**Addendum No. 3**

Smyrna Readiness Center – Packaged Air Terminal Conditioning (PTAC) Units  
Delaware Army Reserve National Guard (DEARNG)  
Smyrna, Delaware  
DEARNG Contract No.: 15-2016  
OMB/DFM Contract No.: MC7601000088  
Tt Project No.: 200-76984-16009

Addendum No. 3  
to  
Drawings and Project Manual

September 18, 2017

LATS VRF System Pipe Trees

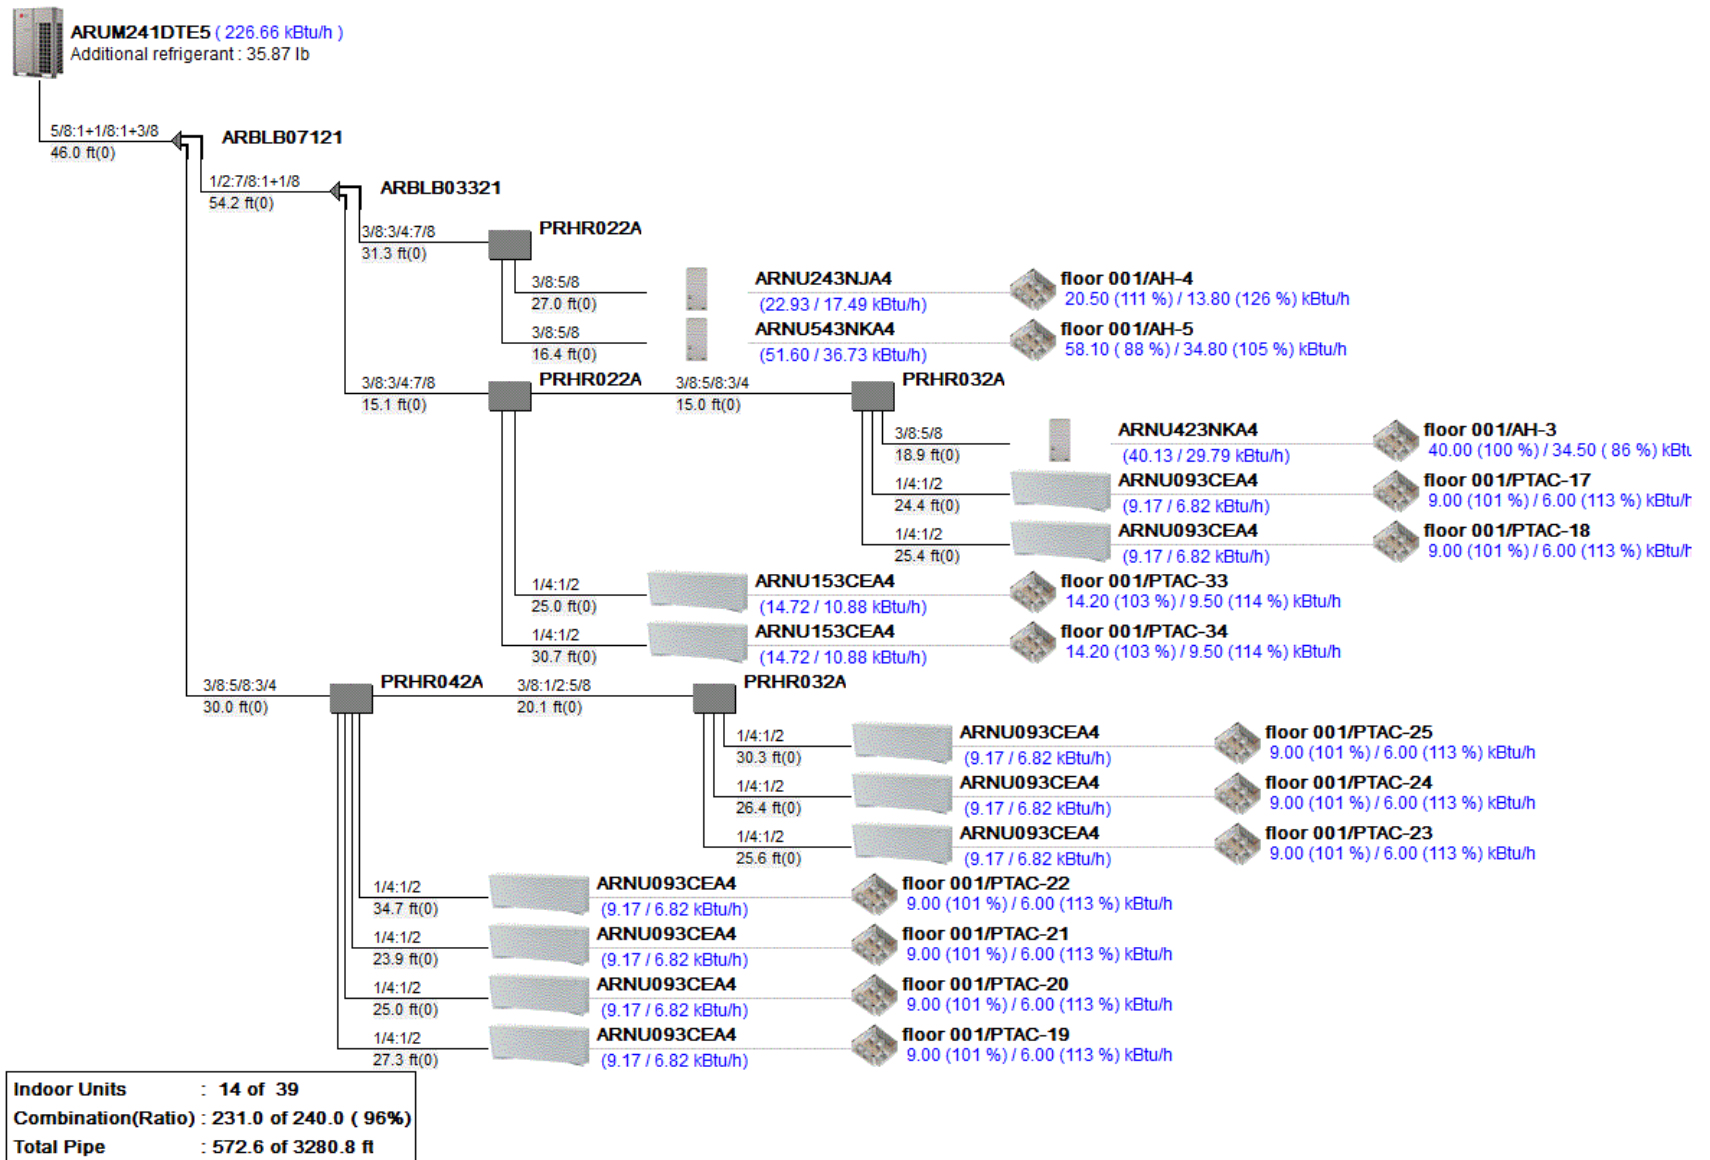
**Question #1:** The pipe sizes on Sheet M-601 are not completely legible.

**Response:** The VRF System Pipe Trees were all enlargements of pdf's from the factory. Attached are the actual pdf's from the factory which are more legible.
